## Report to Sydney Central City Planning Panel

<b>Panel reference</b>	2016SWC007 DA
<b>DA number</b>	JRPP-16-04459
<b>Proposed development</b>	Construction of a 22 storey mixed use development comprising retail and commercial space, 90 residential units, 103 car parking spaces within 5 basement levels, drainage works and associated landscaping
<b>Street address</b>	26 Second Avenue, Blacktown
<b>Applicant</b>	Merhis Blacktown Pty Ltd
<b>Owner</b>	Better Buildings Pty Ltd
<b>Date of DA lodgement</b>	22 November 2016
<b>Number of submissions</b>	1
<b>Regional development criteria (s9.1 EP&amp;A Act)</b>	Capital investment value (CIV) over \$20 million (DA has CIV of \$23.6 million)
<b>All relevant s4.15 matters</b>	<ul style="list-style-type: none"> <li>• Sydney Regional Environmental Plan No. 20 – Hawkesbury-Nepean River</li> <li>• State Environmental Planning Policy (State and Regional Development) 2011</li> <li>• State Environmental Planning Policy (Infrastructure) 2007</li> <li>• State Environmental Planning Policy (Building Sustainability Index: BASIX) 2004</li> <li>• State Environmental Planning Policy No. 55 – Remediation of Land</li> <li>• State Environmental Planning Polic

Figure 2 - Extent of variation (north elevation)  
Source: Conrad Gargett

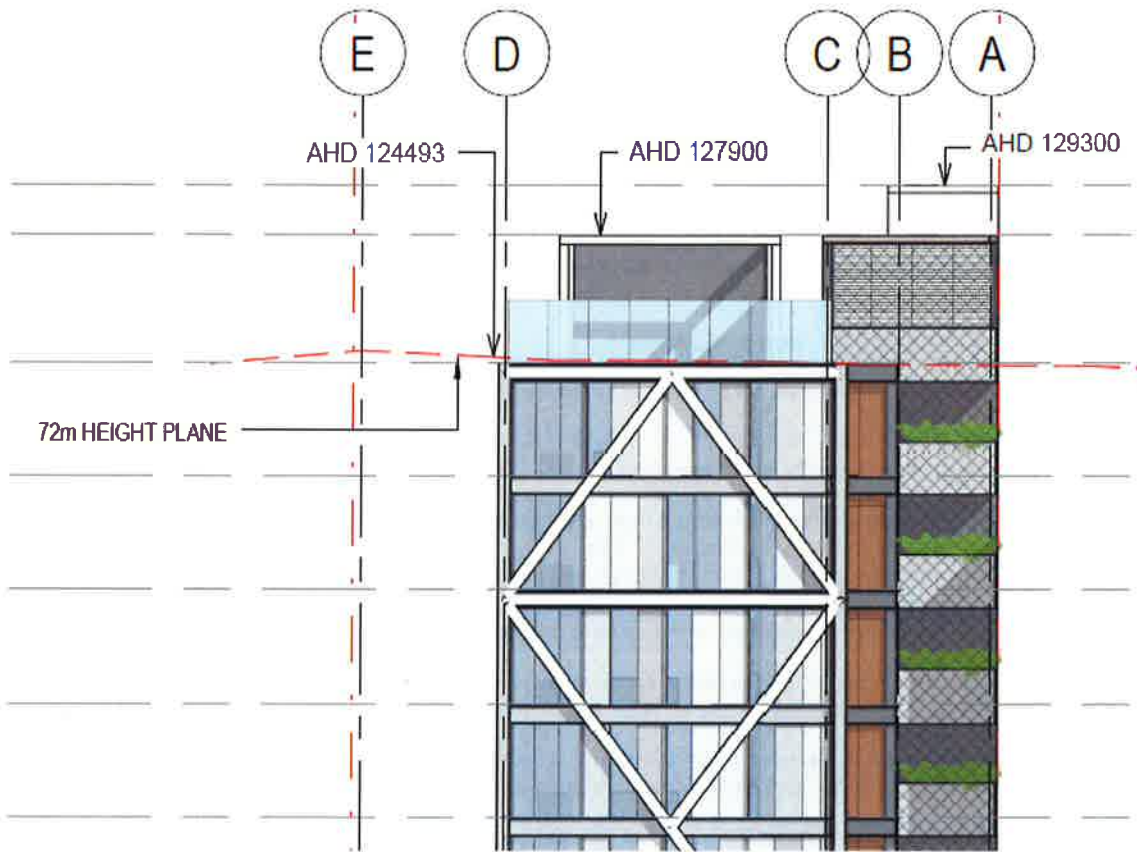
The detailed extent of each variation is provided in **Table 1** below and illustrated in **Figure 2**. It is noted that the lift overruns generate the greatest departure from the Height of Building development standard, resulting in a 5m variation (6.9%).

Component	RL	Maximum Height (m) (above existing ground level)	Variation
Communal open space	124.400	72m	0m
Balustrades	126.2	73.8m	1.8m (2.5%)
Rooftop plant	127.900	75.6	3.6m (5%)
Lift overruns	129.300	77	5m (6.9%)

**Figure 1:** Extract from the proposed Site Plan A1000 demonstrating the relationship of the proposed development site (outlined in red) and development currently under construction at 28 Second Avenue, Blacktown

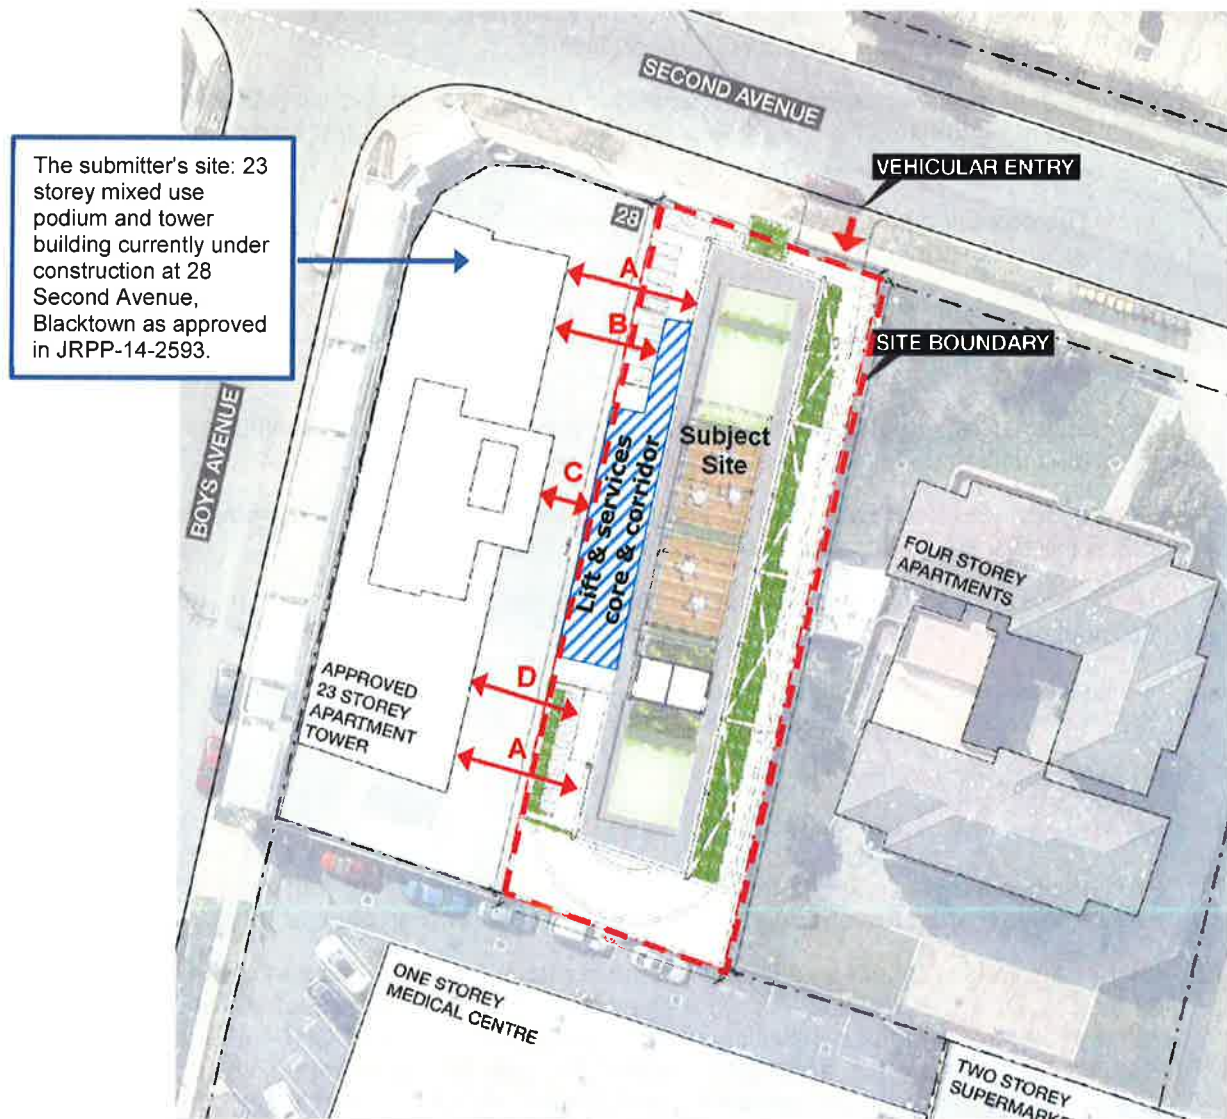
**Table 1:** This table demonstrates the boundary setbacks of the above developments to their shared boundary, as well as the combined distance between these buildings:

<b>Marker</b>	<b>Submitter's development at 28 Second Avenue</b>	<b>Proposed development at 26 Second Avenue</b>	<b>Distance between these buildings</b>
<b>A</b>	Living room and balcony with window openings – 6 metres from the boundary	Blank wall to apartments - 4.7 metres from the boundary	10.7 metres
<b>B</b>	Bedrooms with window openings – 6 metres from the boundary	Access corridor (includes unopenable windows) - 3 metres from the boundary	9 metres
<b>C</b>	Blank wall to the lift and services core – 2.8 metres	Blank wall to the lift and services core – nil setback to the boundary	2.8 metres
<b>D</b>	Living room, balconies and bedrooms with window openings – 6 metres from the boundary	Blank wall and 1 window opening to apartments - 3 metres from the boundary	9 metres

**Figure 5:** Extract from the Blacktown and Mount Druitt CBD Studies, prepared by Bates Smart dated June 2016, demonstrating the building envelopes proposed and approved for the Blacktown CBD as at June 2016.

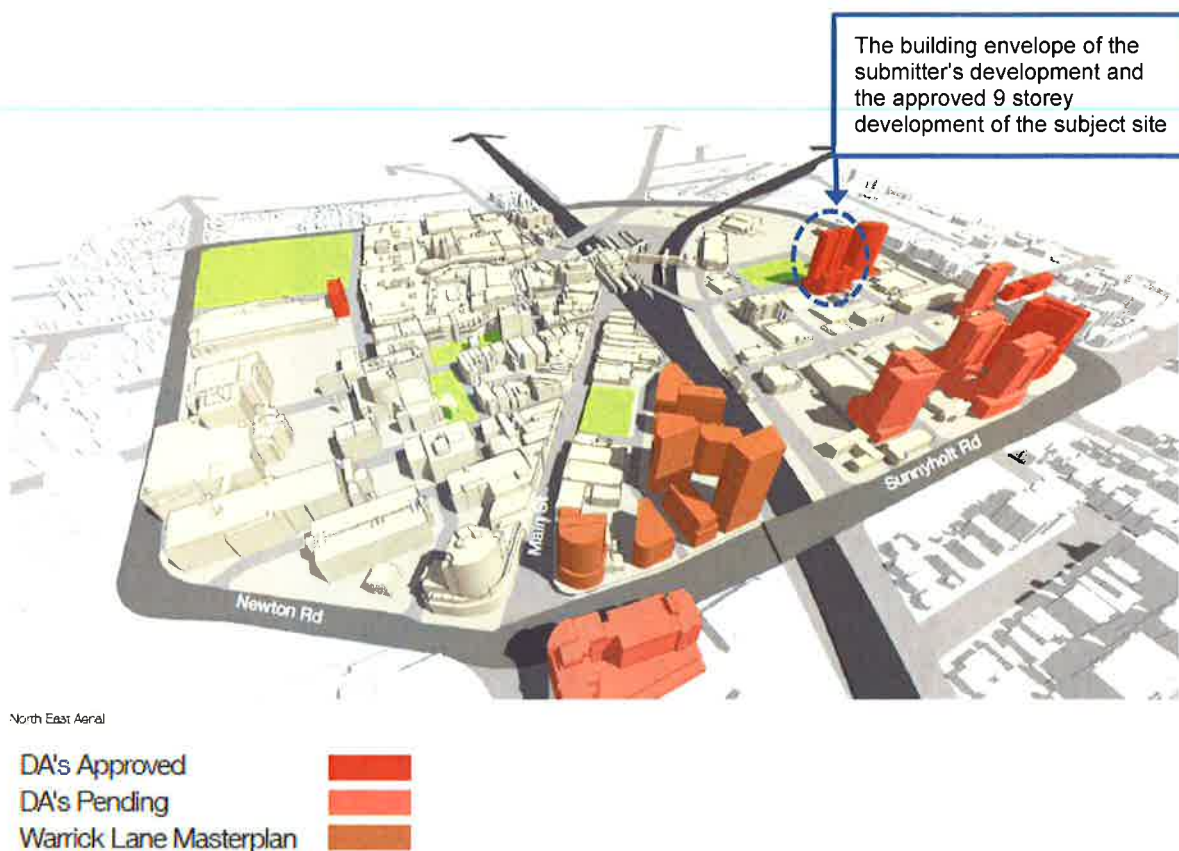
The submission objects to their future residents' views to the east being obstructed by this development. We do not consider that view corridors from the objector's site to Sydney city are automatically available, guaranteed or a right. As demonstrated in **Figure 5** below, the submitter's site and the site the subject of this DA, are generally centrally located within the Northern Precinct of the CBD. The redevelopment of the CBD envisages and supports the redevelopment of sites at the perimeter of the CBD to create a strong skyline, street edges and to create 'gateway effects' for entry into the CBD. This will result in low likelihood for developments (other than those at the perimeter of the CBD) to maintain full and unobstructed distant views to Sydney City to the south-east in the long term.

Therefore, we do not consider that obstruction of views is a sufficient reason to warrant the refusal of this DA.
